**TOWN OF MOUNTAIN VILLAGE
REGULAR DESIGN REVIEW BOARD MEETING AGENDA
THURSDAY JULY 11, 2024, 10:00 AM
MOUNTAIN VILLAGE TOWN HALL
455 MOUNTAIN VILLAGE BLVD, MOUNTAIN VILLAGE, COLORADO
TO BE HELD HYBRID THROUGH ZOOM:**

4.	10:17	30	Nelson/ Applicant	Quasi-Judicial	Consideration of a Design Review: Final Architecture and Site Review for Lot 166AR2-10, 10 Stonegate Dr, pursuant to CDC Section 17.4.11.

PROJECT NAME:
SINGLE FAMILY
LOT 10, STONEGATE
MOUNTAIN VILLAGE, CO

1 Landscape Plan
SCALE: 1" = 10'

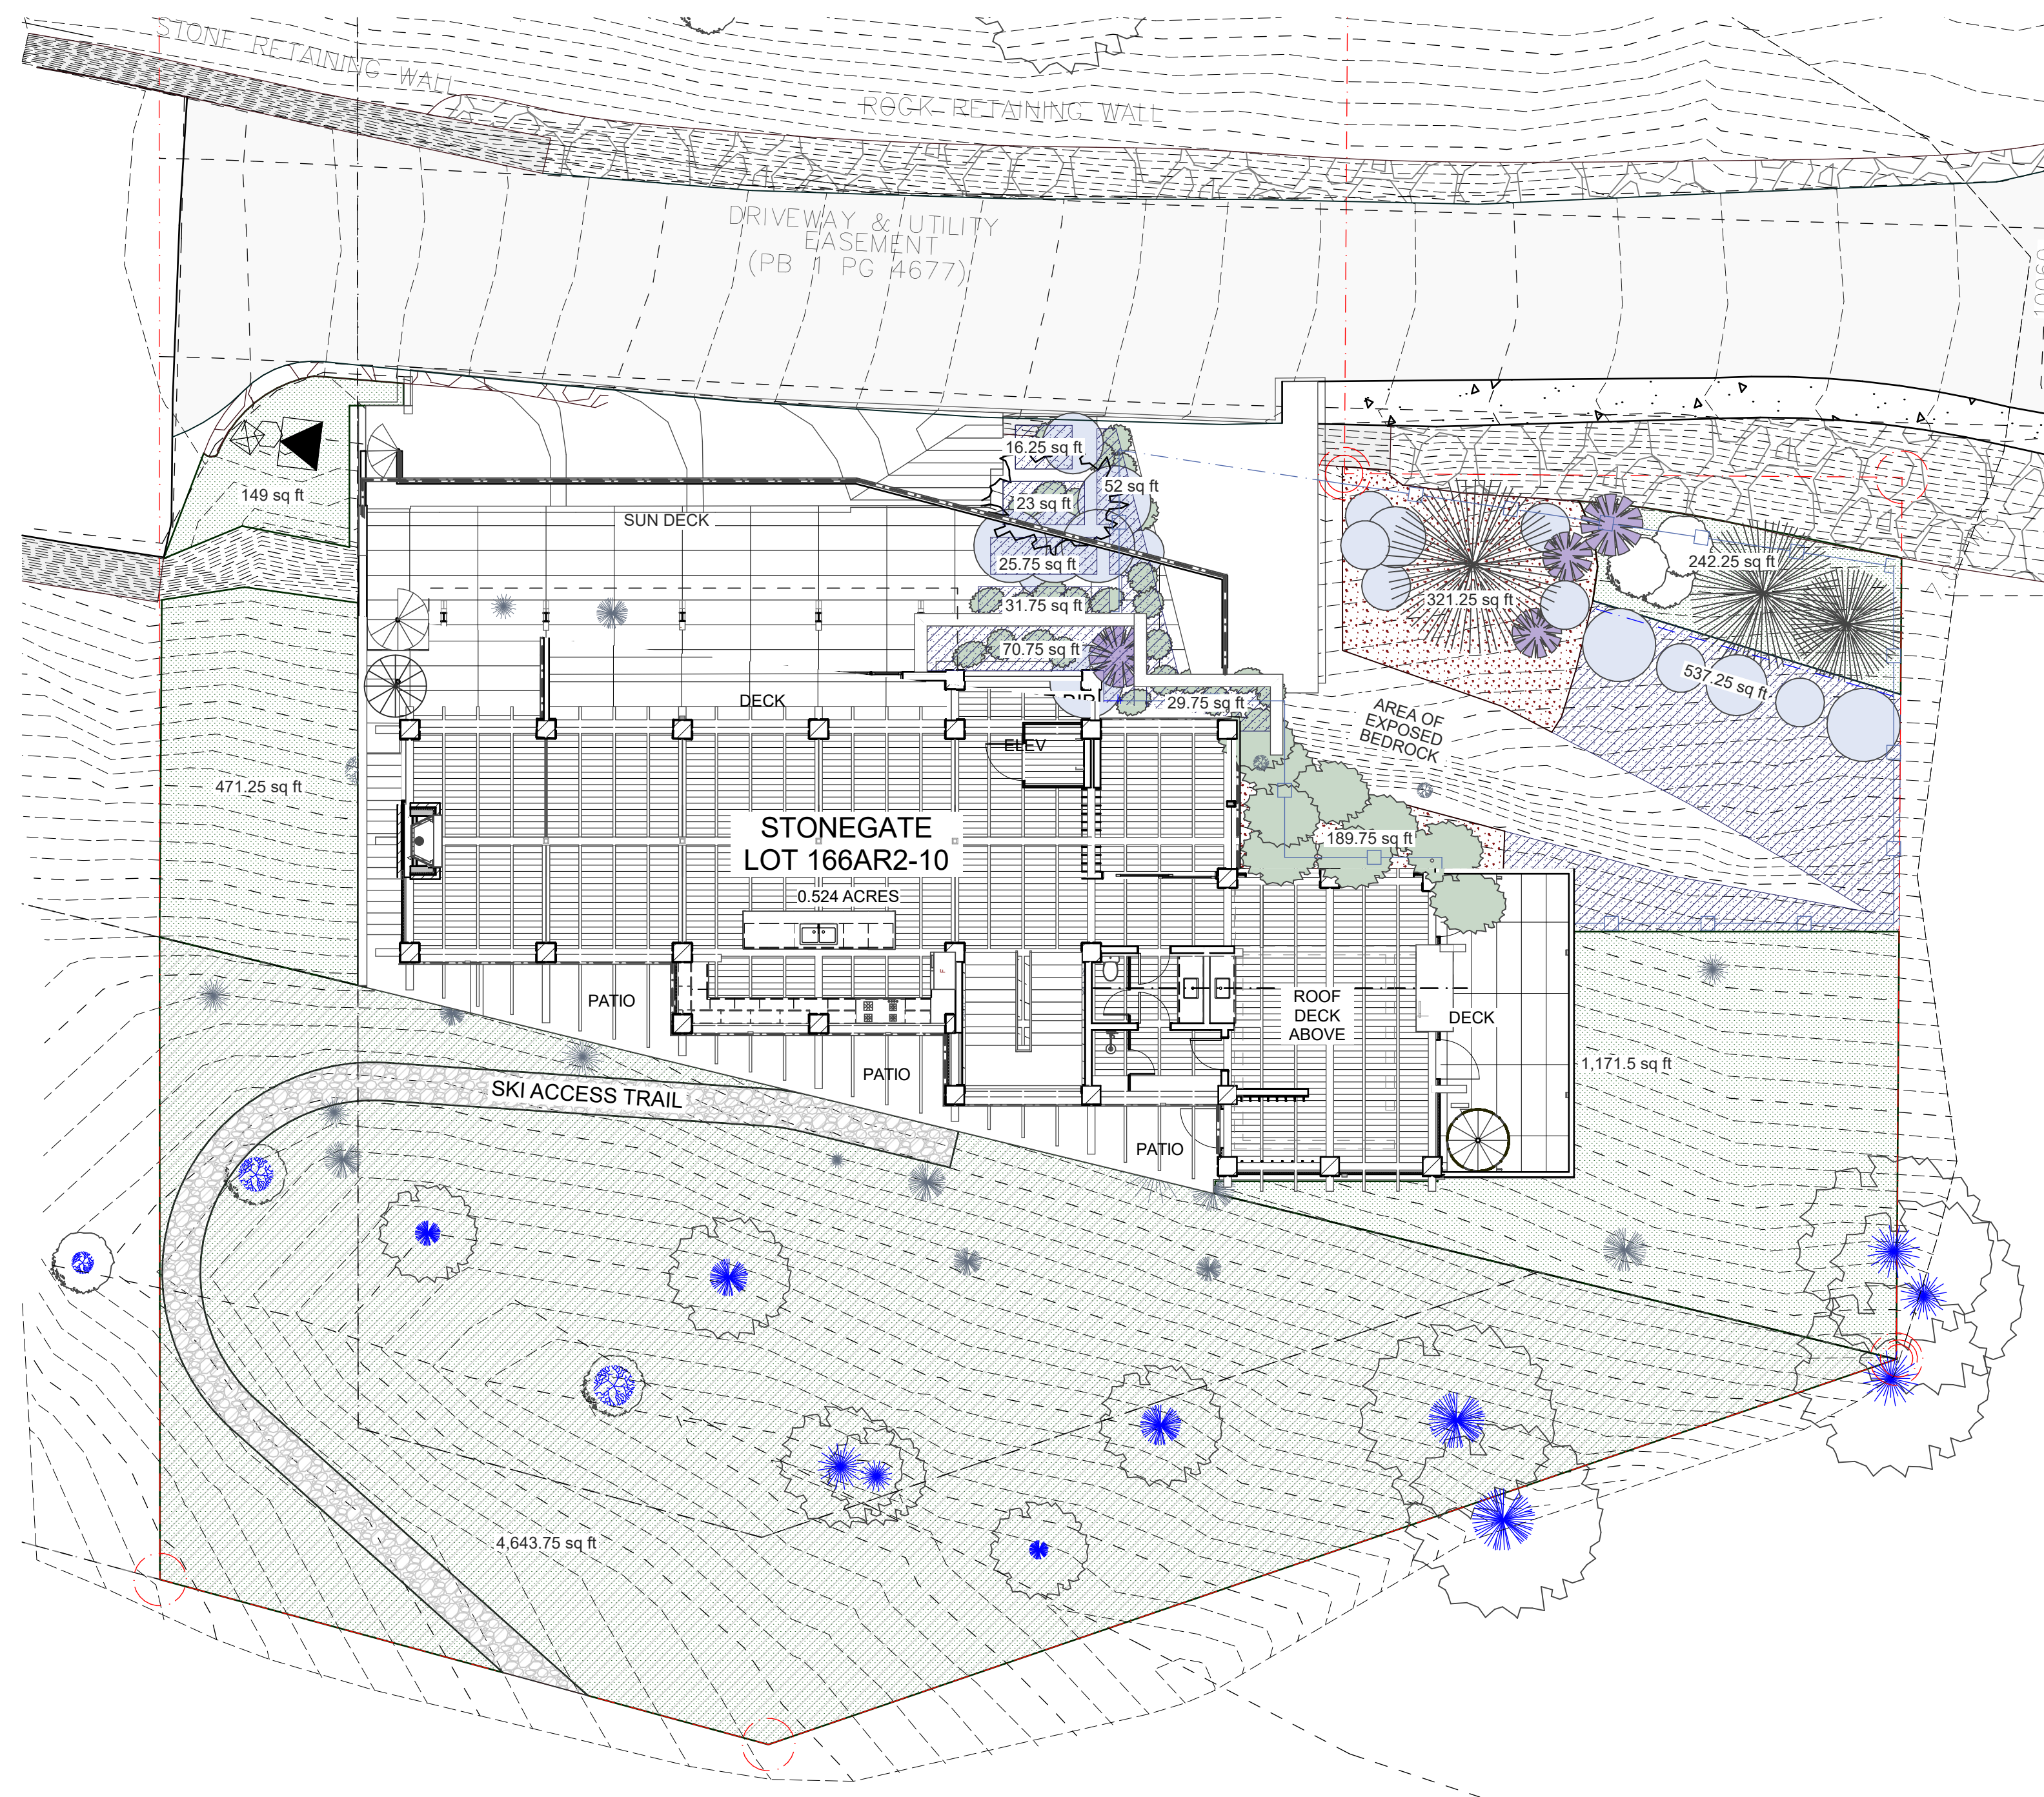
Staff: An initial landscaping plan was provided on sheet A-004 of Exhibit A. The applicant is proposing the addition of 3 evergreen trees, 3 Aspen trees or multi-stems, 1 ornamental Dogwood tree, and 60 ornamental trees or shrubs along with retaining the existing vegetation outside of the Zone 1 fire mitigation area. The revised design also incorporates new planting islands on the north side of the building that would be integrated into the structure.

All recommendations of the Town Forester have been incorporated into the landscape plan, meeting the conditions of the IASR.

EXTERIOR LIGHTING LEGEND

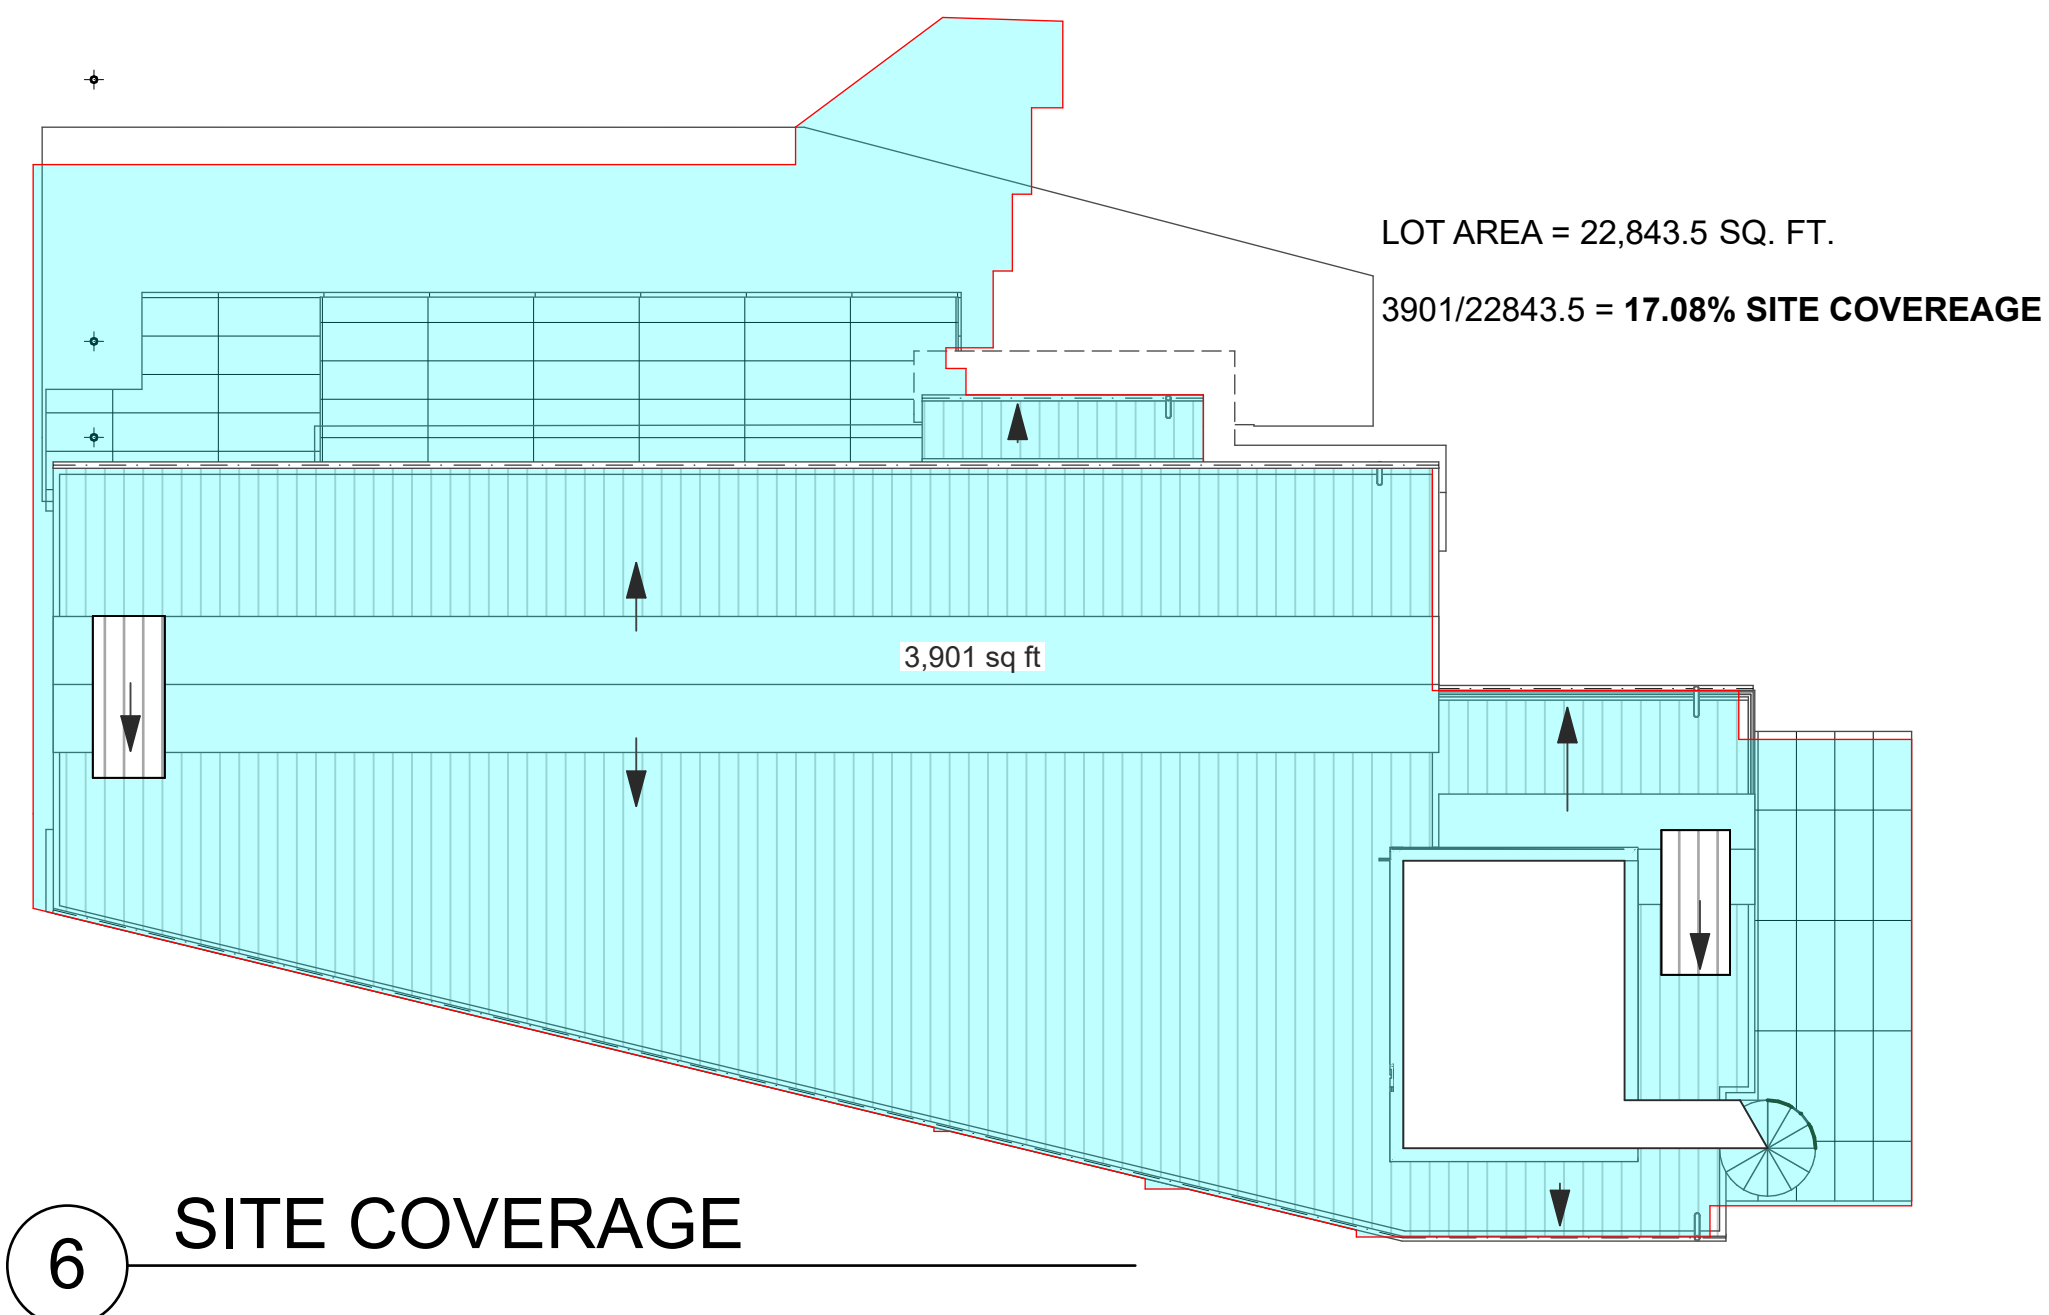
Staff: The applicant has provided an initial lighting plan on sheet A-005 and A900 of Exhibit A. This illustrated the lighting types and locations. The plan proposes the use of three exterior lighting fixtures: an exterior sconce, a step light, and recessed downlights at the entry. The wall sconces are proposed adjacent to the three garage doors, the step lights are proposed for the deck areas, and the recessed downlights are proposed for the entryway. All lighting fixtures meet the requirements of the CDC.
